Subject: SunPower Comments on Data Model Inputs
Wildlife Corridor Study for the Carrizo Energy Solar Farm Project,
Docket No. 07-AFC-8

**Requests for Clarifications and Information Regarding the
Proposed Wildlife Corridor Study for the Carrizo Energy Solar Farm Project,
Docket No. 07-AFC-8**

Figure 1: CEC Corridor Study Vegetation Mapping

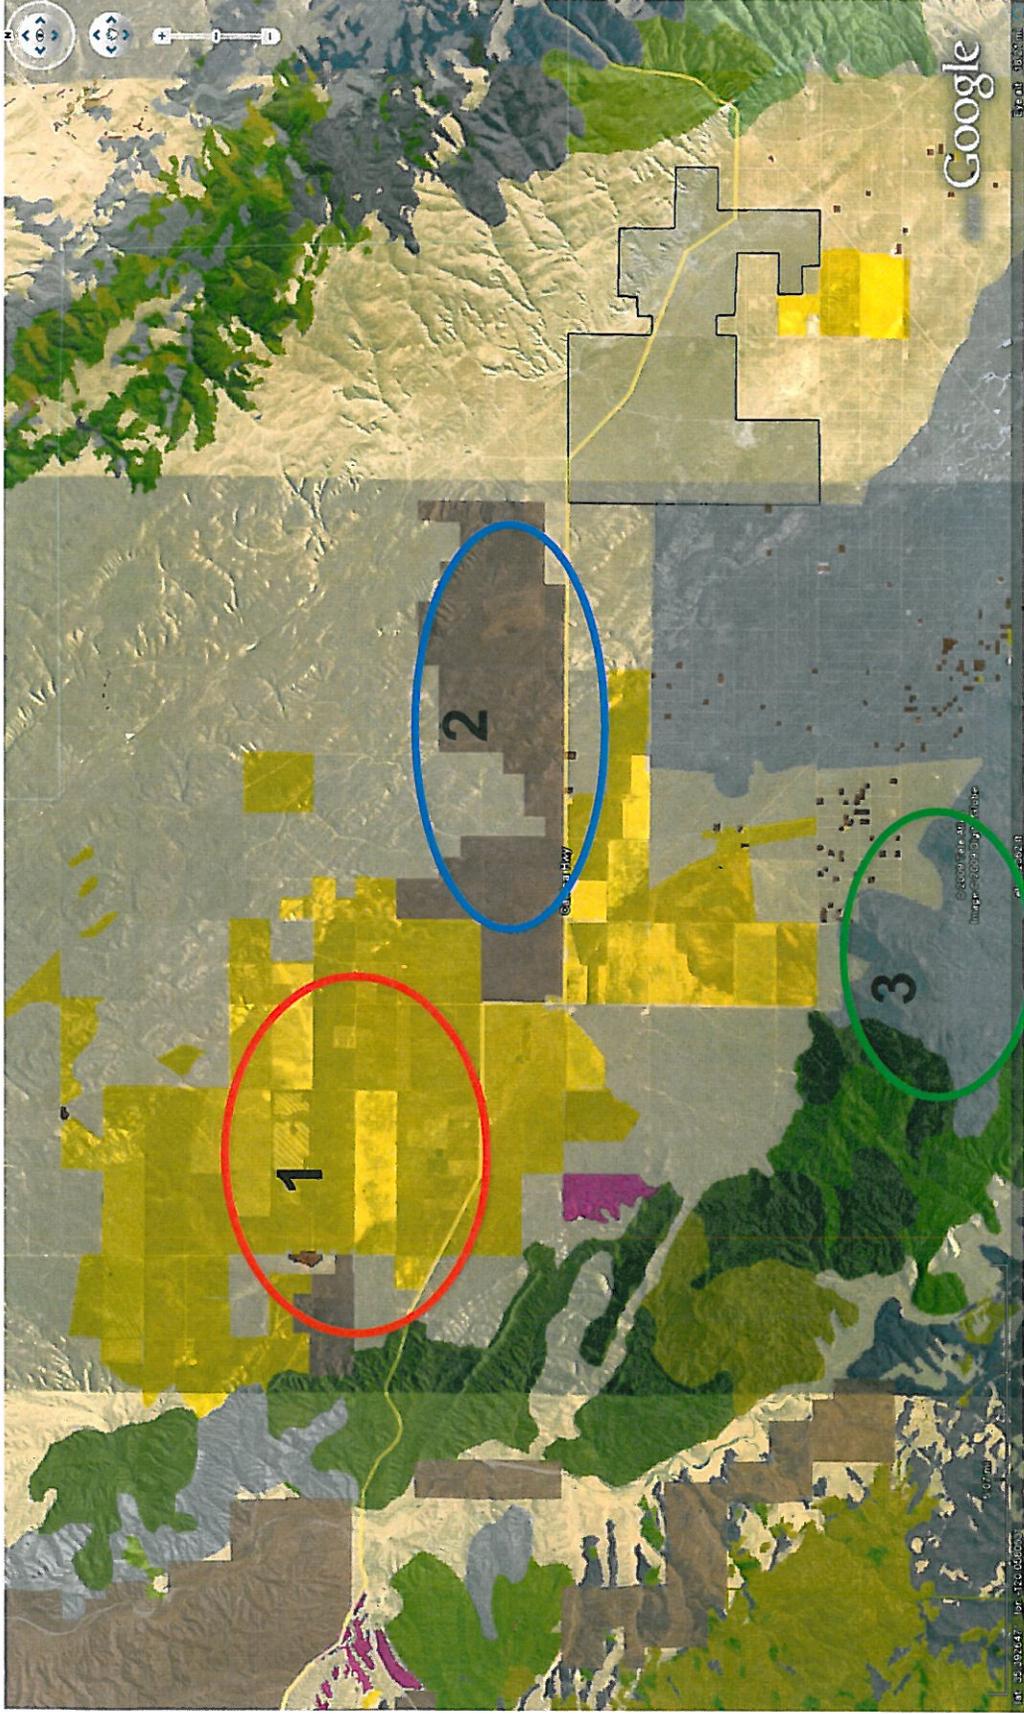
Three specific examples follow, which are located as items 1, 2 and 3 in the attached figure. In each of these areas, the statewide mapping from the County of San Luis Obispo shows the vegetation as Annual Grassland, but the SC Wildlands shows a different vegetation type.

1. In the area of the OptiSolar project and its immediate vicinity (shown as 1 in the attached figure), the vegetation type has been changed to one or two shades of yellow, representing some form of agricultural use (presumably cropland or dry land grain crops).
2. In the land north of and adjacent to SR 58 (shown as 2 in the attached figure) the vegetation type has been changed to Pasture.
3. In the land generally southwest of the California Valley subdivision area (shown as 3), the vegetation type has been changed to Alkali Desert Scrub.

In the SC Wildlands proposal, Task 1, Step 1, includes updating vegetation with 1-meter resolution aerial photographs “if necessary.” Apparently this update occurred in selective areas; and this process should be documented and reviewed. With the three specific examples cited, the effect of these mapping changes is to increase the permeability of lands on or near the proposed solar power projects and to decrease the permeability elsewhere. Whether by coincidence or intent, this type of change may affect results significantly, and illustrates the importance of very close review.

- either GIS shape files with attributes, or an improved color scheme and vegetation legend, so that distinctions can be made between vegetation types with similar or identical colors
- an explanation of how the vegetation mapping update was performed, and who did that work (i.e. SC Wildlands, the County of SLO, other agencies or consultants)
- an explanation of how seasonality was considered by which experts in distinguishing among the various agricultural vegetation units
